Ref: 1022-04-LET-02
File:

re: DAMPIER DRAINAGE – SUB-CATCHMENT C1 – C4 GHD MODEL AUDIT

Thank you for the ongoing works regarding design review of Dampier drainage system. Please find herein reporting of the model audit for sub-catchments C1 – C4 based on site visit and workshop with City of Karratha personnel on 29 November 2016.

Figure 2 – Open Drain Profile for Catchment C1 to C2

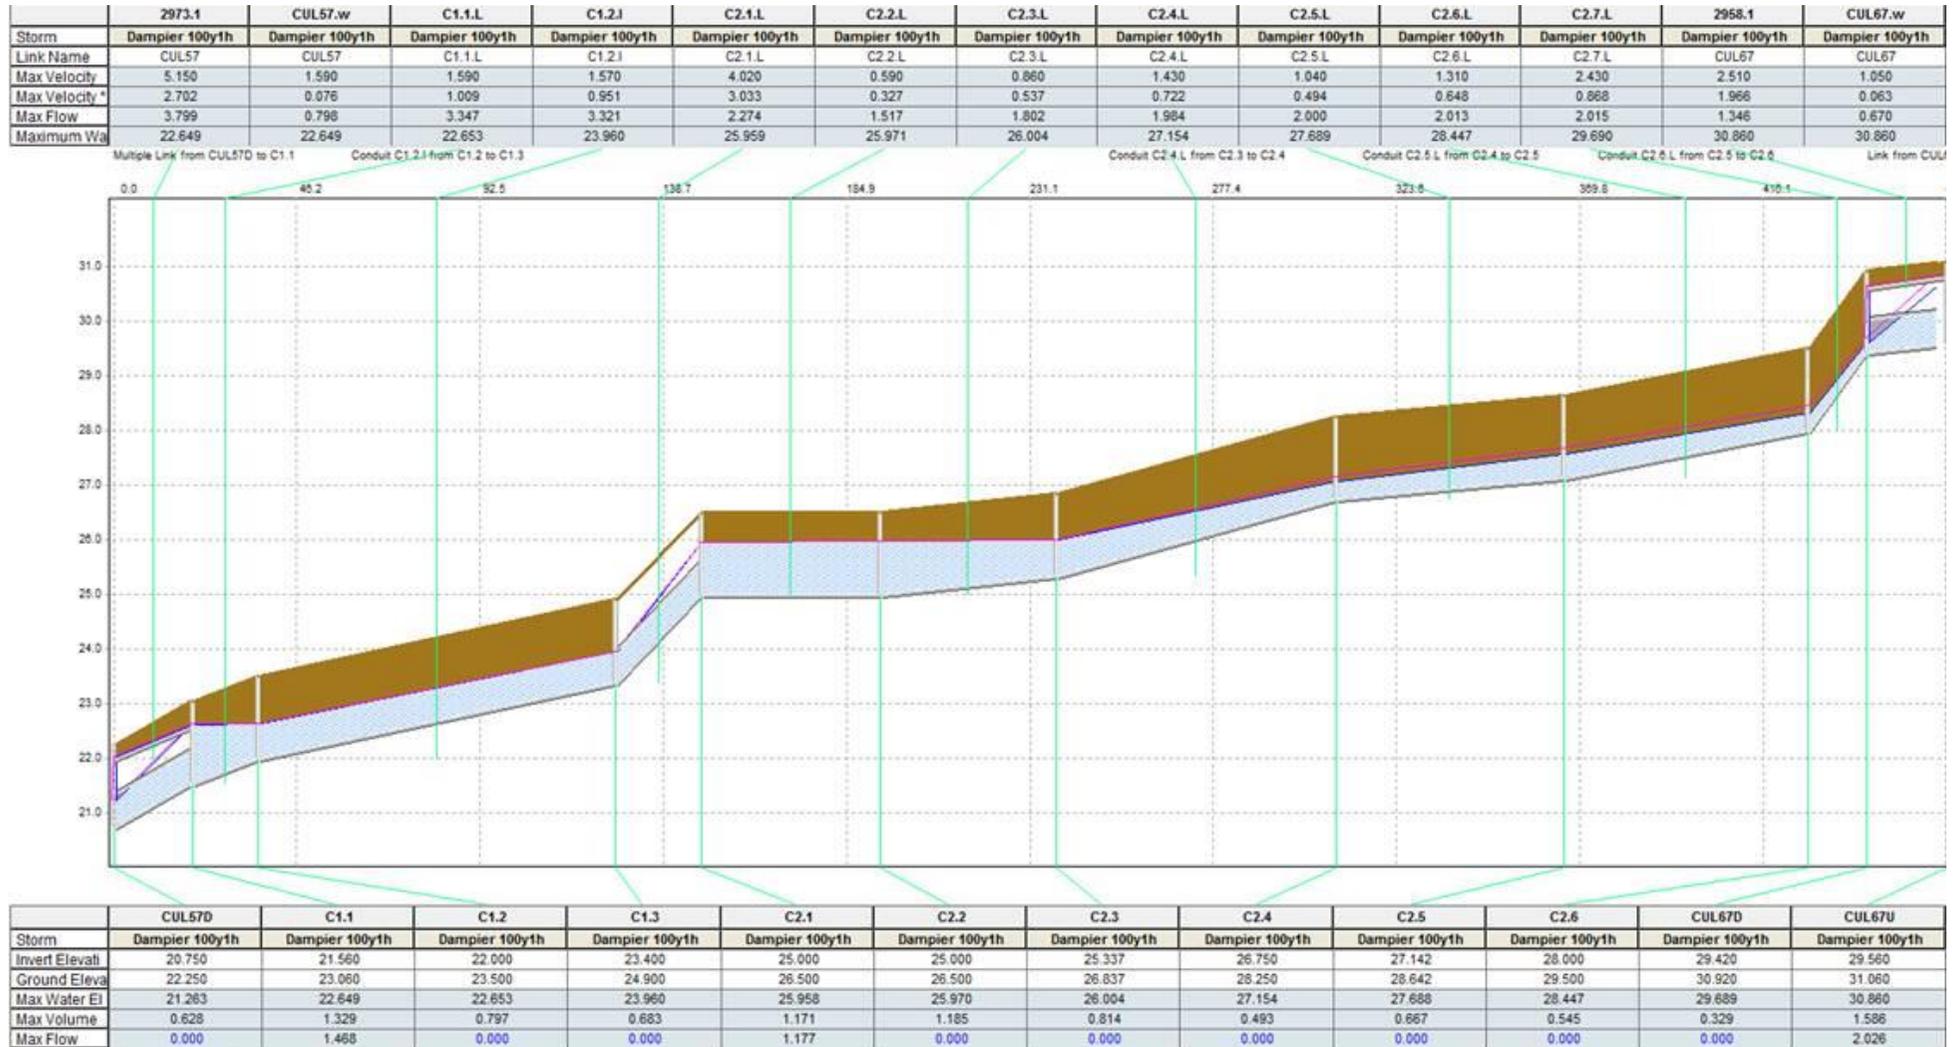
The modelling shows that the flow depth generally varies between 1.09m downstream to 0.45m upstream resulting in flooded widths of 8.5m and 4.7m, respectively. Refer to Attachments 2 and 3.

This is significantly less than the 15m flooded width and 1.5m depth determined in the GHD report.

Based on the modelling outcomes, the open drain cross-sectional area can potentially be reduced by up to 50% from the GHD model (item 2 above).
